Report to the Advisory Committee of Experts for Nuclear Pressure Equipment

ASN Report reference CODEP-DEP-2017-019368

Session of 26 and 27 June 2017

**Analysis of the consequences of the anomaly in the
Flamanville EPR reactor pressure vessel head domes
on their serviceability**

Figure 7: Areas not inspected on the upper dome of the Flamanville EPR reactor pressure vessel with regard to the search for under-cladding flaws

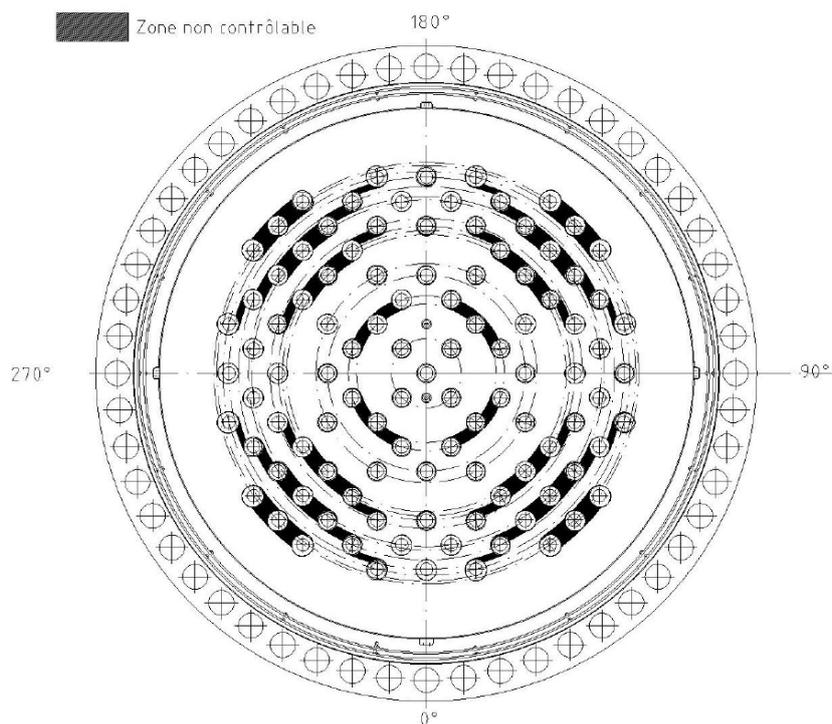
With regard to the upper dome, the entire surface could not be inspected. The inspected zone corresponds to 92% of the cladding of the dome. The remaining 8% corresponds to the inaccessible zones defined in Figure 7. The entire centre of the dome, over a diameter greater than 1.2 m was thus inspected, which covers the potentially segregated zone.

Figure 41: Evolution of reference temperature T_0 versus the carbon content taken from the rapporteur's analysis of the test programme toughness results

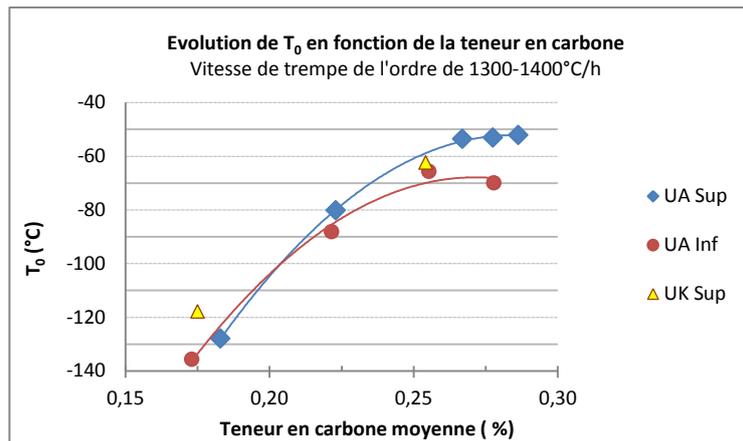
The interpretation of the fracture toughness results made by the rapporteur reaches the same conclusion. At an identical quenching rate, the reference temperature T_0 increases significantly for carbon contents of between 0.18% and 0.25%. The slope of the curve is then inverted for carbon concentrations of 0.25% or higher and the value of T_0 flattens out, reflecting the improved quenchability at carbon contents of between 0.25% and 0.28% (Figure 41).

The rapporteur considers that the RCC-M curve indexed on the optimum temperature or the RT_{NDT} in the segregation zone is able to cover the toughness data of a zone with carbon contents capable of reaching 0.32% on the surface, owing to the more favourable quench effect between one-quarter thickness and the outer surface (Figure 41).

Figure 42: Comparison of the various index temperatures of the RCC-M curve examined in the light of the average carbon content measured on specimen³⁴, at comparable quenching rate (~1300-1400°C/h)

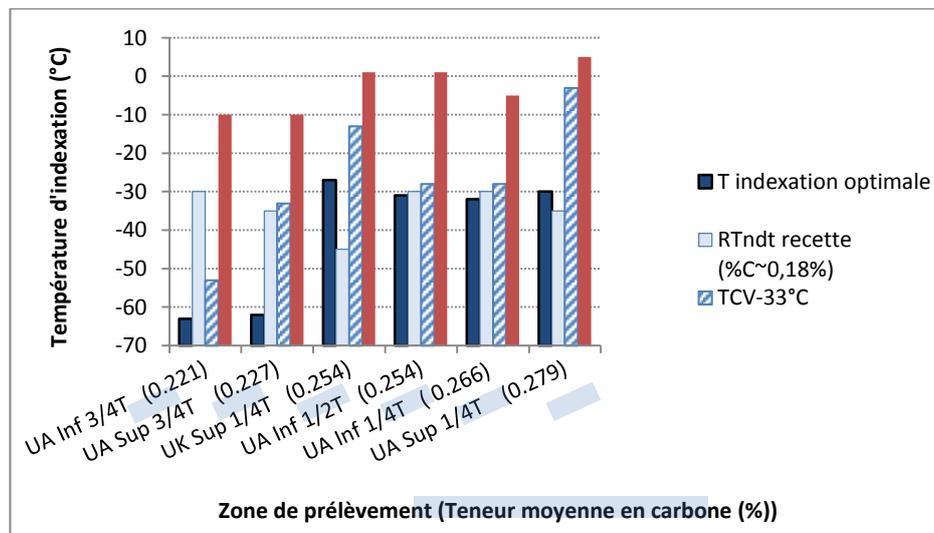
The rapporteur observes that the optimum index temperature of the RCC-M curve is below the temperatures T_{CV-33} and T_{NDT} whatever the depth of the dome at which the samples are taken, as shown in Figure 42. This complies with request n°11³⁵ in the ASN letter in reference [7].

Figure 44: Main flow and core bypass flow in normal operation

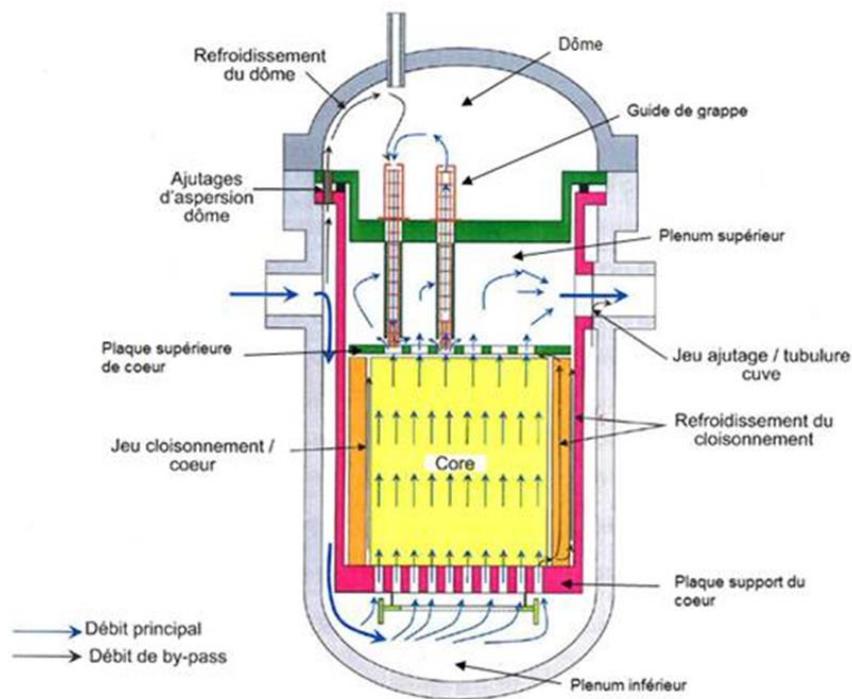
With regard to the upper dome, the characterisation of this situation was established on the basis of a calculation carried out with the CATHARE system software, which uses “OD” point models to represent the upper parts of the pressure vessel, in particular the upper head volume upon which the upper dome is positioned. At the moment where the safety injection cold water penetrates through the spray nozzles and the upper control rod guide outlets (see Figure 44) situated in the upper head volume, complex three-dimensional phenomena may occur (more specifically fluid recirculation loops). The rapporteur considers that the point modelling adopted by Areva NP is unable to represent these phenomena. The penalising nature of the fluid temperature calculated in this way in the upper dome is therefore not confirmed.

Figure 49: Central part of the Flamanville EPR reactor pressure vessel seen from above – zone to be examined and positions of flaws looked for

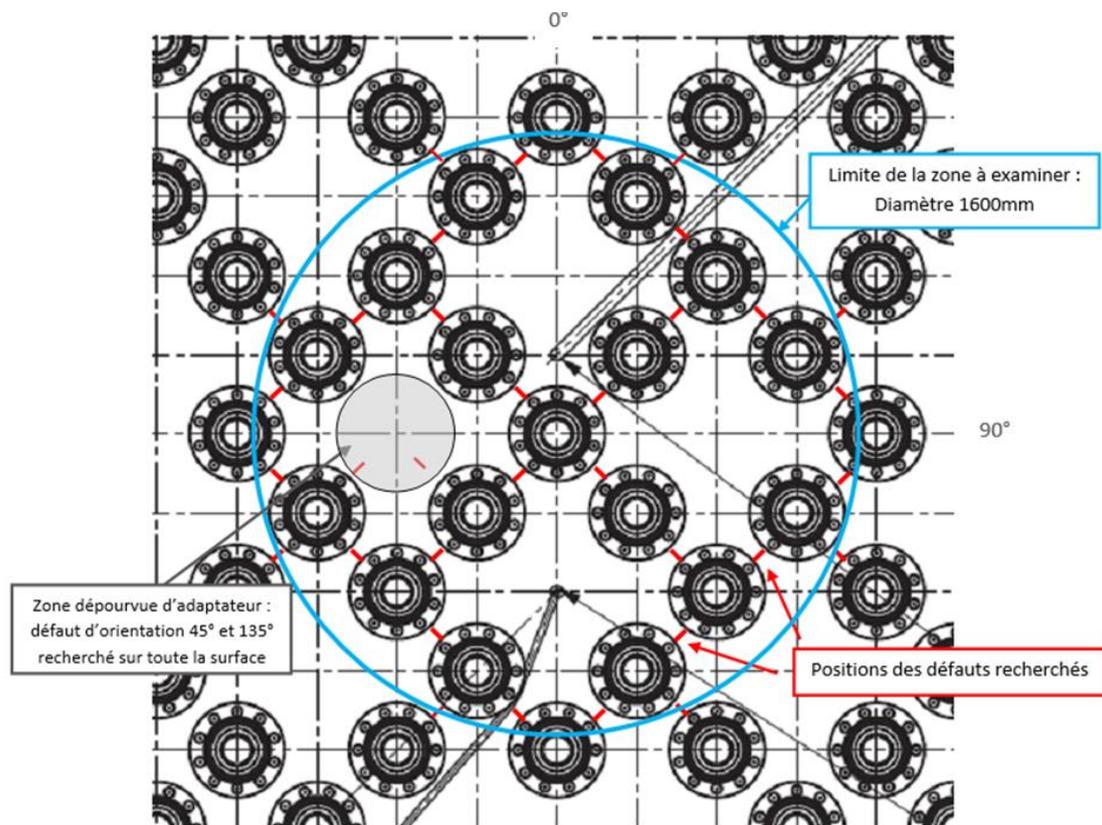
The rapporteur notes that the inspections to which EDF is committed cover a more restricted zone for the closure head than for the bottom head, more specifically because of the search zone limited to the shortest ligaments between adapters (Figure 49) and the impossibility of detecting all the flaws in the vicinity of the adapters (50% at nozzle corner, 80% in continuous part, see Figure 50). The rapporteur also notes that, as with the bottom head, only faults disoriented by less than 3° with respect to the search direction would be detectable. These restrictions imply that the proportion of flaws perpendicular to the surface and detectable in the outer first twenty millimetres is very small.

Figure A9 : "Envelope RCN" flow rate profiles for the hot shock calculations[44]

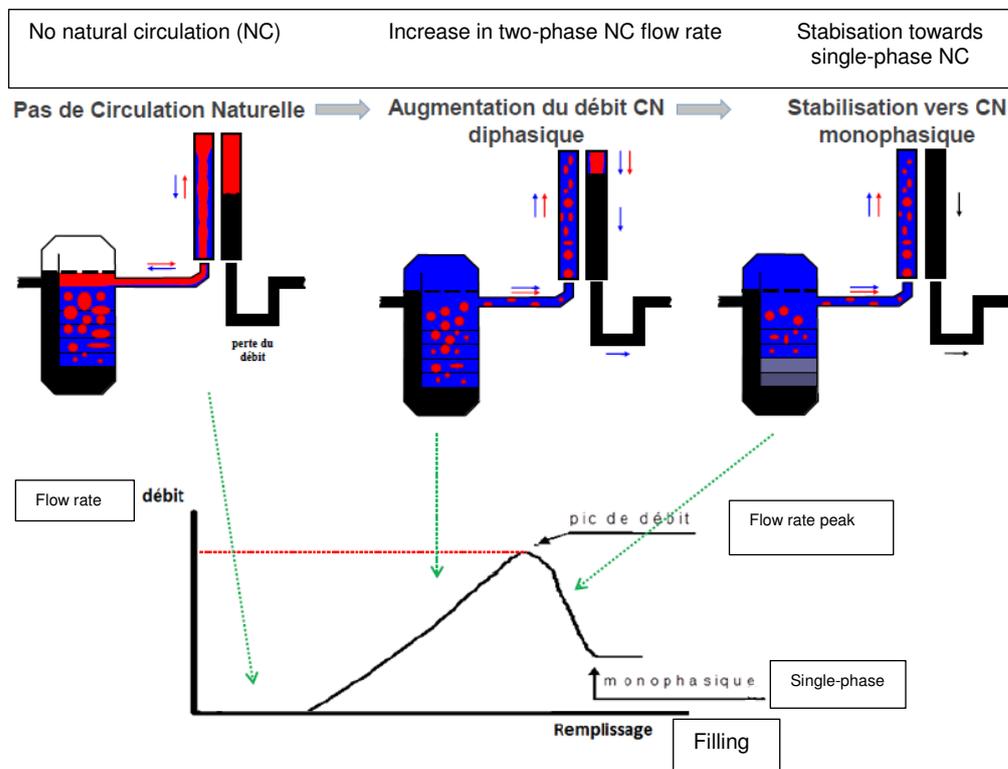
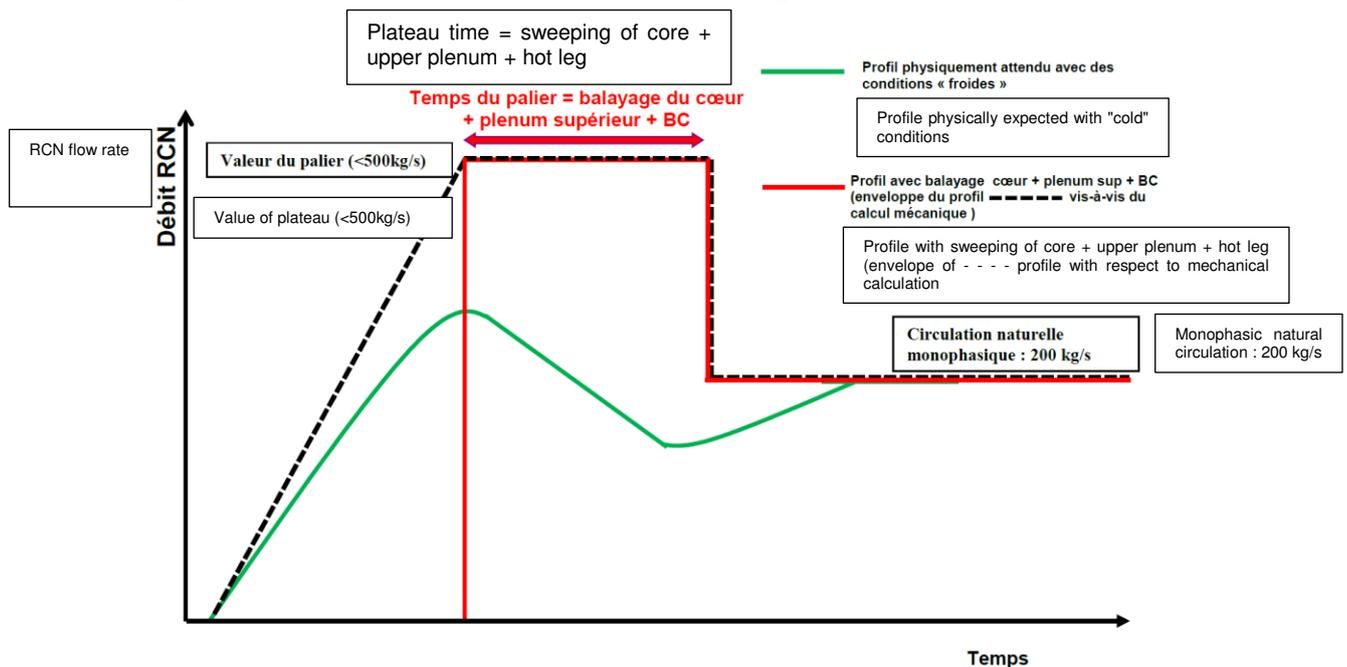
Questioned on the justification for the chosen RCN flow rate profile (see Figure A6), Areva NP provided the elements which are detailed in notice [59]. It first gave a recap of the main physical phenomena governing resumption of natural circulation (Figure A8). Areva NP used the results of the PKL III test as a basis for defining an approach allowing verification of the conservative nature of the RCN flow rate considered for the hot shock analysis, and in particular the flow rate peak value and duration. On the basis of these observations, Areva NP modified the flow rate profile and adopted the following profile (Figure A9):
